ARMIDALE SECONDARY COLLEGE - NEW MULTI-PURPOSE HALL

BUILDING CODE OF AUSTRALIA VOL 1 2019 – ACCESS & DDA FINAL CONCEPT DESIGN REVIEW

JUNE 2020

Report prepared for	NBRS Architecture Level 3, 4 Glen Street, Milsons Point NSW 2061 Attention: Macella Salzmann
Report prepared by	Metro Building Consultancy Suite 102, 12 Mount Street, North Sydney NSW 2060 Consultant: Sean Moore
Report reference	17194-ASC-DDA-R02
Job number	17194
Date	19 th June 2020

From another accessible building connected by a pedestrian link

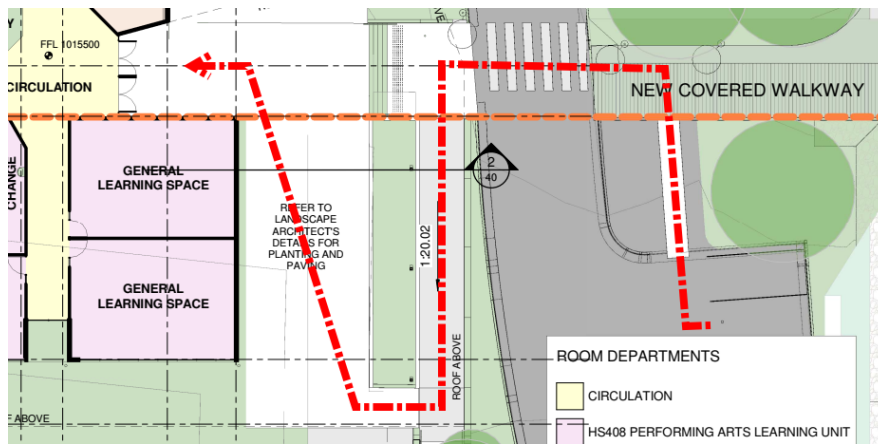
Further detail of the accessible paths of travel from the adjacent Zone 8 Ag building are required in the developed design drawings.

Pedestrian entry points

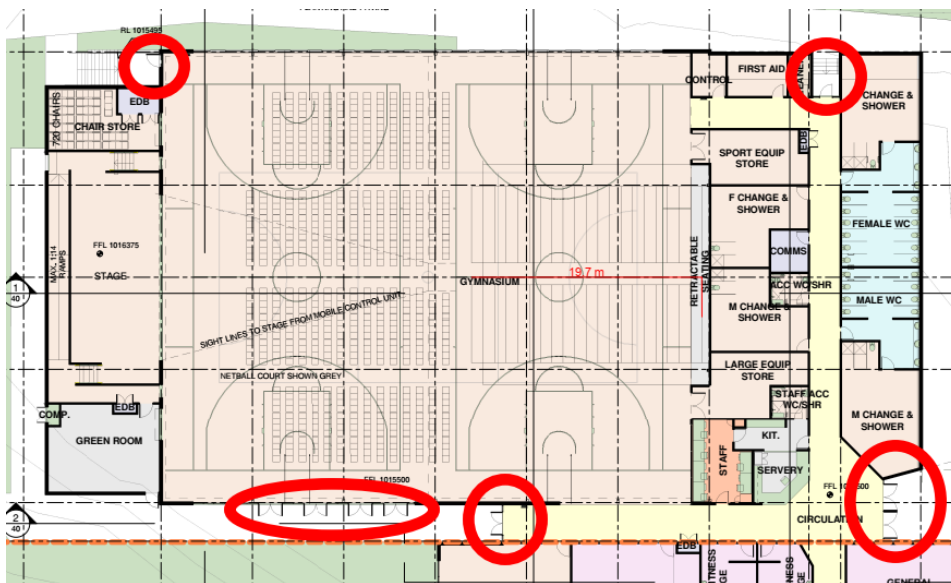
Due to the building having multiple points of entry that could be considered as accessible, the developed design drawings are required to provide details of which doorways are ‘entrances’, which of these are proposed to be used as accessible entry points and which doorways are only used as exits.

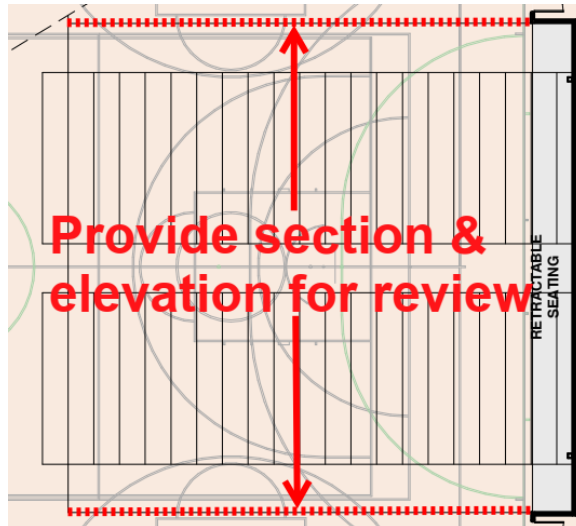
The protection of the underside of the retractable seating is required to be access for compliance. Provide details including sections, elevations and details of any side panels for review to determine if it create an overhead obstruction and therefore if tactiles or a suitable barrier is required.

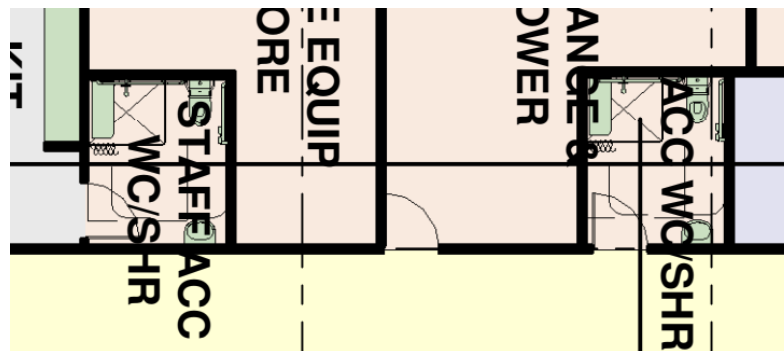
The developed schematic design drawing are required to show further detail of the set out of the accessible toilets.
